Reference: U.S. Geological Survey TRIGA Reactor (GSTR), Docket 50-274, License R-113, Request for Additional Information (RAI) dated October 2, 2012

Subject: Follow-up responses from questions of phone conference on 12/20/12

**GSTR RAI Responses: February 8, 2013**

Figure 1, limiting core configuration core layout

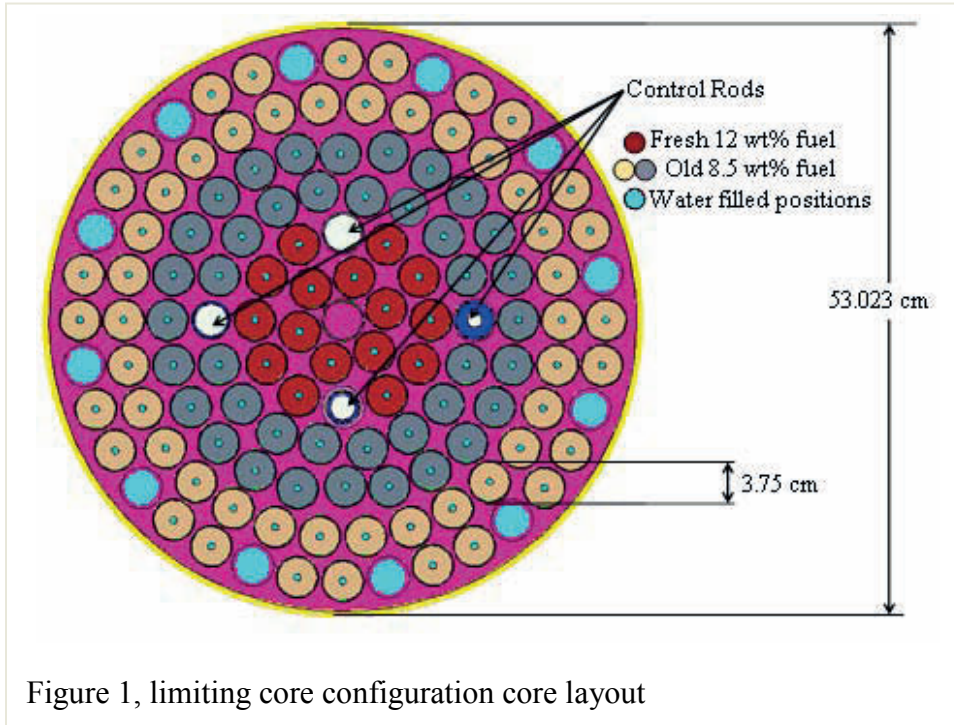
**9. Core map showing the contents of the core lattice positions for the LCC and the OC:**

Figure 3, power profile for the limiting core

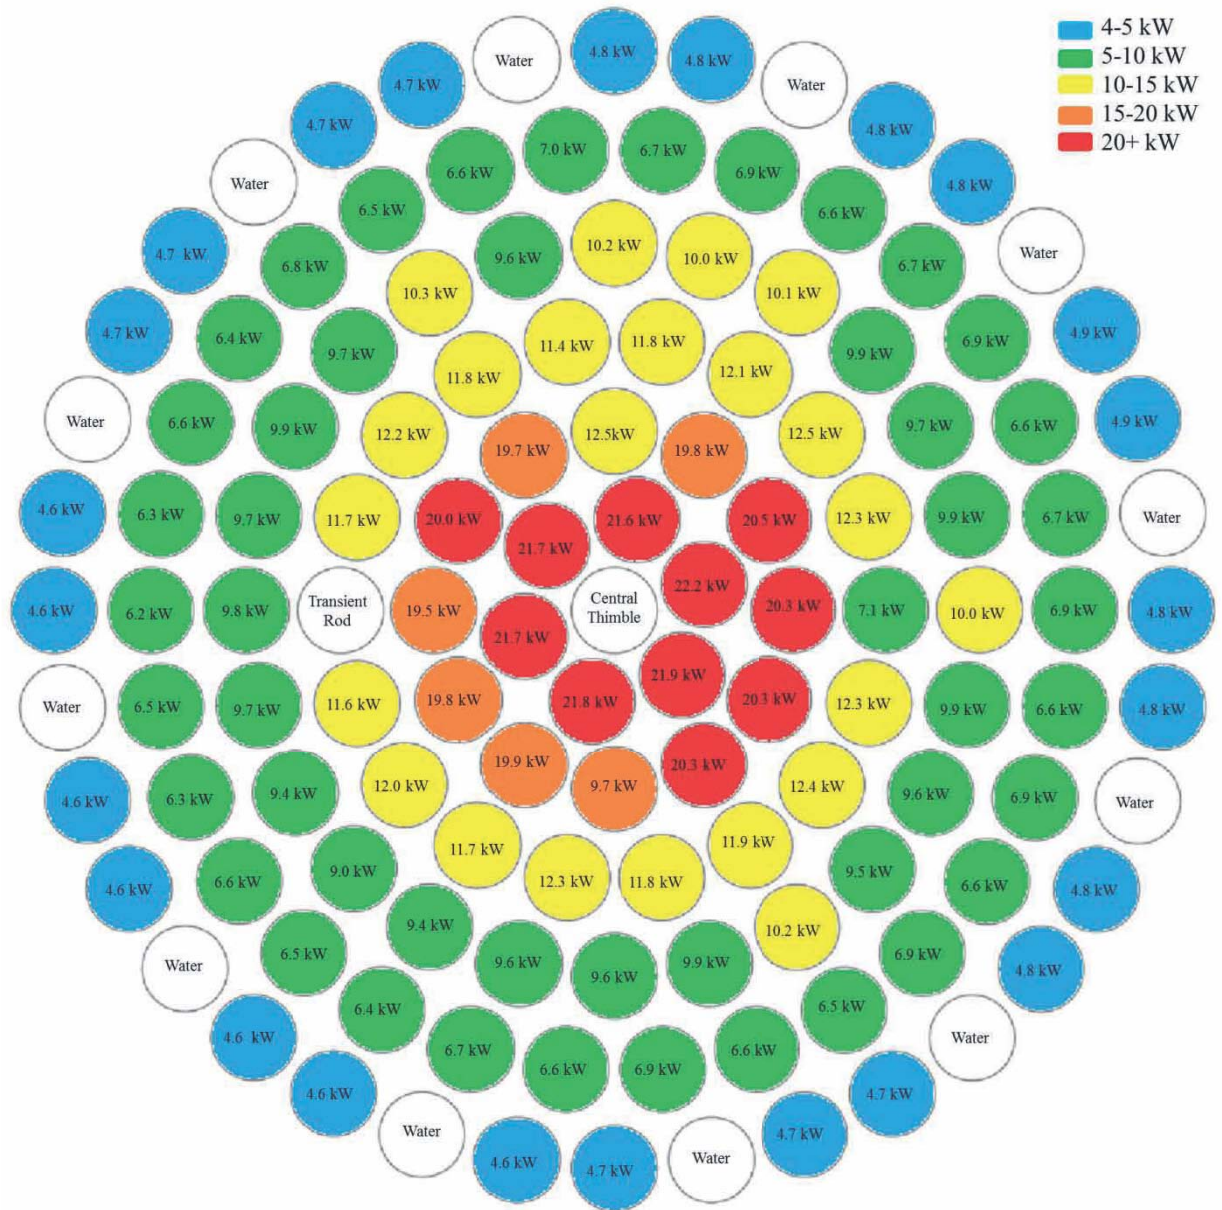
Power Distribution Graphics for the OC & LCC showing power in kW per fuel element

\$3.00 Pulse Results – LCC Hot Rod

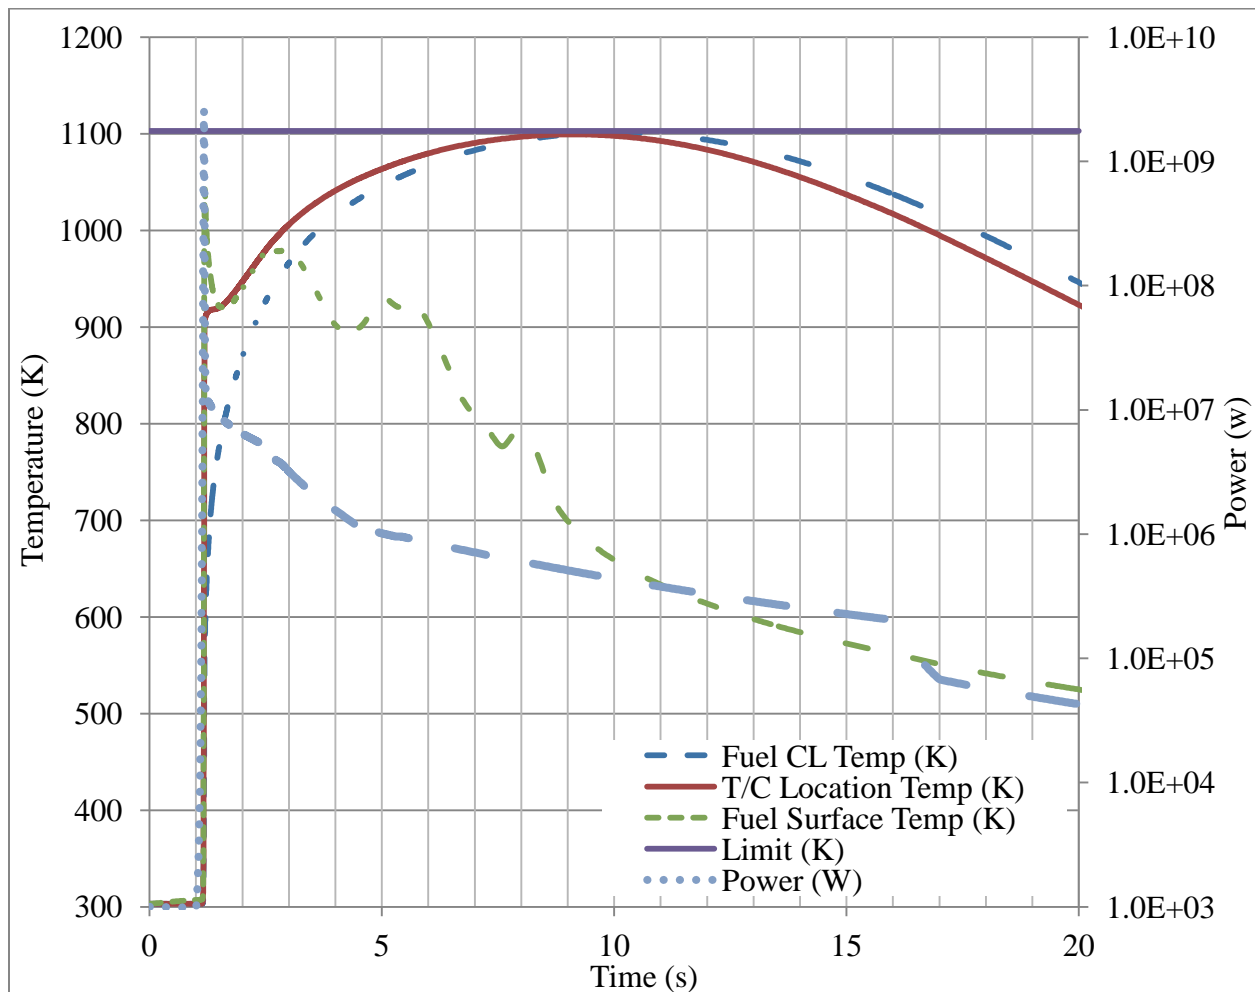
- Characterization of the response of GSTR to a reactivity pulse and an uncontrolled rod withdrawal transient event. Included are the final power achieved in the event, the duration of the event, and the sequence of events.

These values are consistent with the Technical Specifications of the GSTR at the time of the analysis, along with information provided from the GSTR staff for values not covered in the technical specifications. In all of the following graphs, the limit line marks an upper bound of the thermocouple temperature at 830 °C as conservatively recommended in report TRD 070.01006.05. It is noted that the TRD report discusses concerns with uranium loading of 20 wt% and higher, although all of the GSTR fuel is less than 20 wt%. The \$3.00 pulse analysis shows a peak fuel temperature of 1104 K (831°C) which is one degree above the 830°C recommended level, but the 830°C level has a 44°C safety factor built into it so that the 831°C temperature has no safety significance. The smaller pulse analyses show peak fuel temperatures well below the 830 °C recommended level and even farther below the 1150 °C safety limit.

Figure 13.1, Limiting core configuration layout

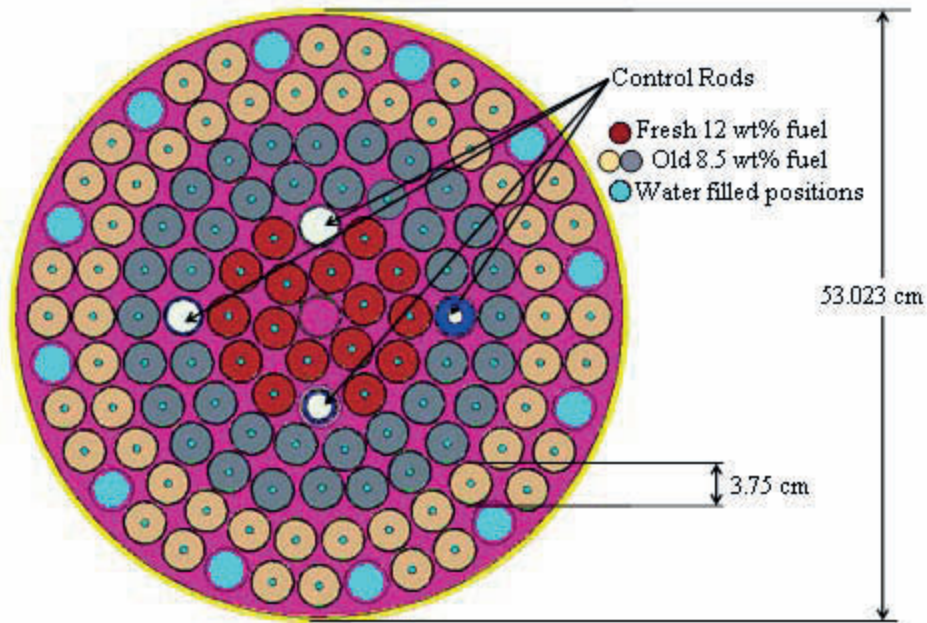
- Please explain the use of 22 kW per fuel element, and why it was used rather than using the hot rod power determined from the LCC. Clarify the basis for the value used in the accident analysis.

It is conservatively assumed that the GSTR is fueled in the limiting core configuration shown in Figure 13.1, and that the reactor has operated continuously at 1 MW for a period of one year. Thus, all halogens and all noble gases (except Kr-85) are at their saturation activities. The highest-power density fuel element fails and releases the noble gases and halogens to the gap between the cladding and the fuel. This highest-power-density element has a conservative power density of 22.44 kW. The fission product inventory of halogen and noble gases are given in Table 13.1 for this element. The inventory assumes a saturated activity is present and is based upon the fission yield for each isotope. Table 13.1 was calculated from Oregon State University's (OSU) fission product inventory for the same MHA scenario by multiplying OSU's number by the ratio of the highest power density element at the GSTR (22.44 kW) to the highest power density element at the OSU reactor (15.9 kW).
